PRELIMINARY OVERALL AREA DEVELOPMENT PLAN
for
ROYAL OAKS

PRELIMINARY OVERALL AREA DEVELOPMENT PLAN APPLICATION (POADP)

POADP # 445 - B

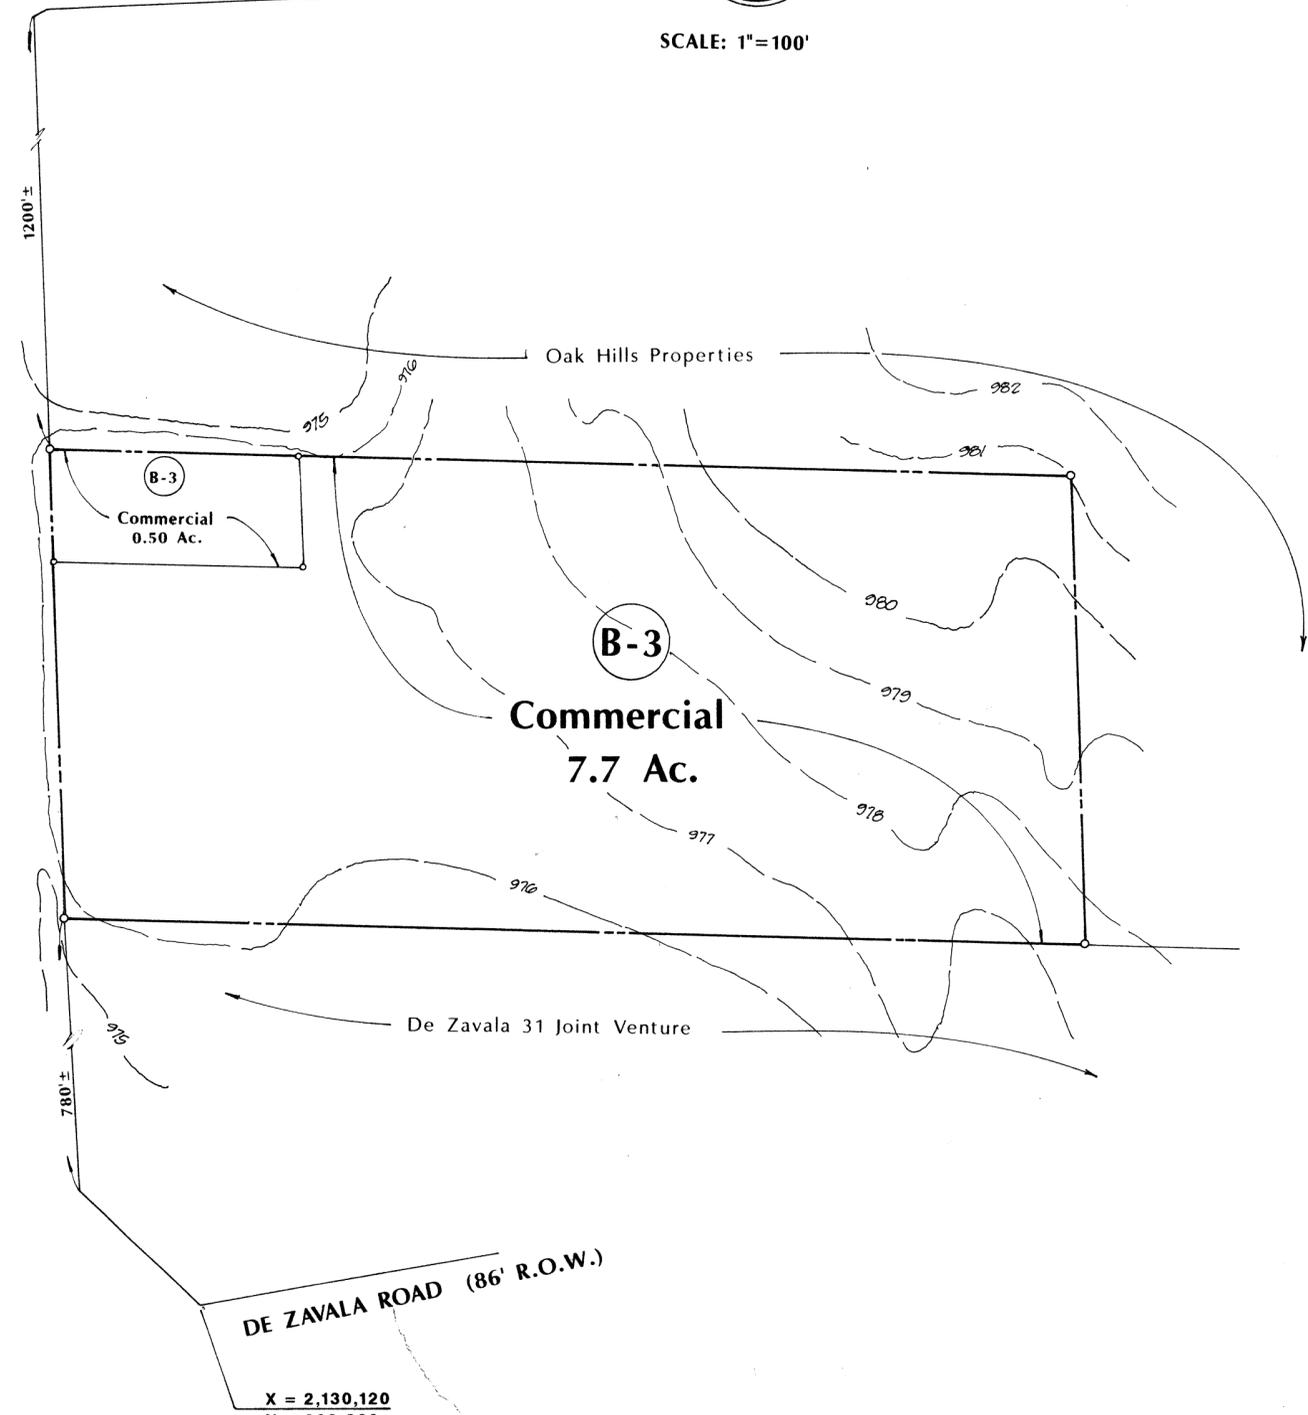
The City Staff Development Review Committee has reviewed Royal Oaks Veterinary Corp. Subdivision Preliminary Overall Area Development Plan # 445 - B. Please find enclosed a signed copy for your files. Although your plan was accepted, please note the following:

- This development will probably need to conform to requirements associated with development over the Edwards Aquifer. For additional information about these requirements you can contact SAWS at 704-7305.
- Access issues along State facilities will need to be resolved with the Texas Department of Transportation (TXDOT). For additional information about these requirements you can contact TXDOT at 615-5814.
- Based on the topography, a Flood Plain Study and drainage review will probably be required during the platting process.
